# Worksheet and Comment Form

**EAST HIGH  
STREETSCAPE**

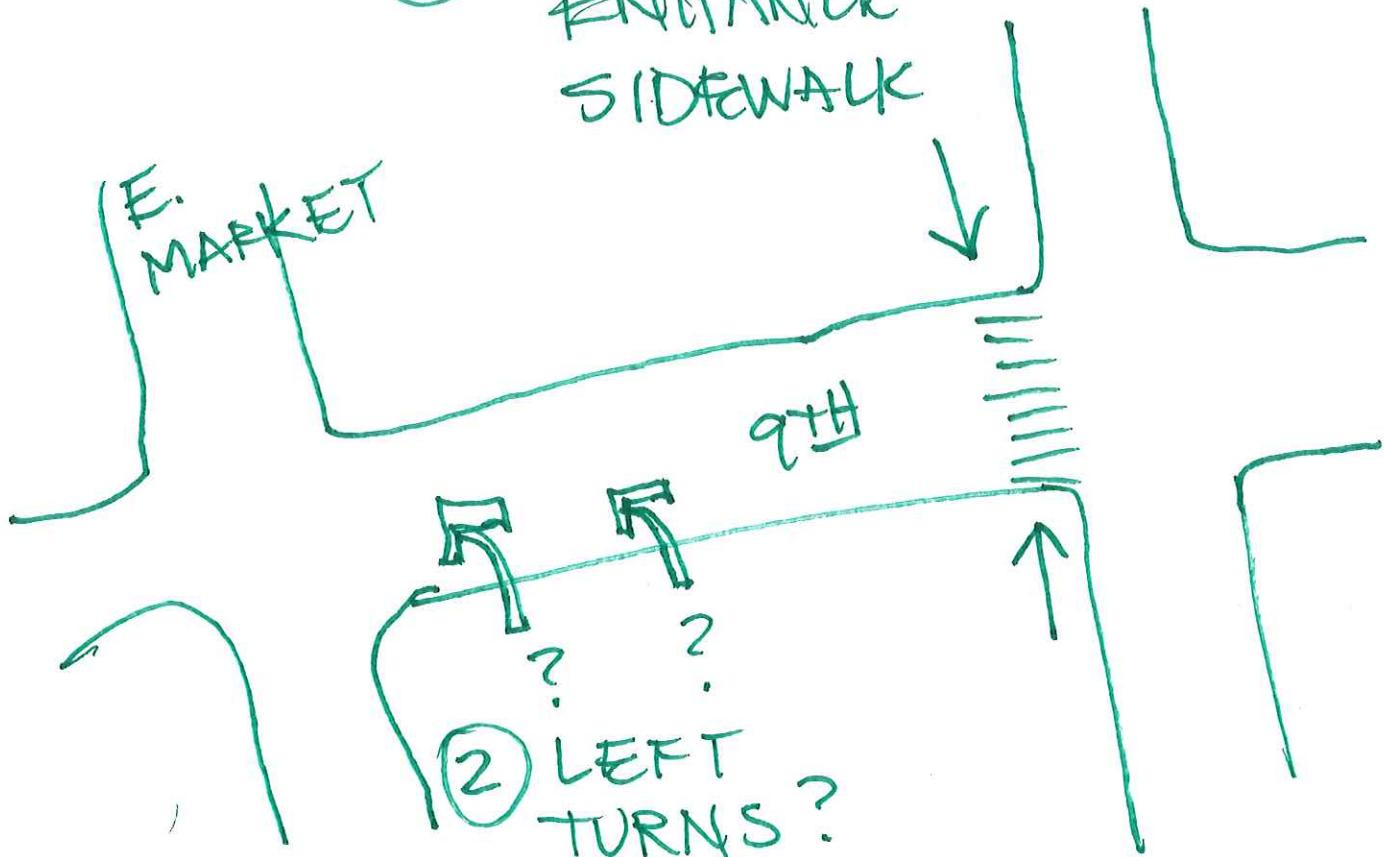
SEE DRAWING/COMMENTS  
ON BACK

① SUGGEST  
ENHANCE  
SIDEWALK

③ How CAN STRIPED MEDIUM  
BE INTERESTING?
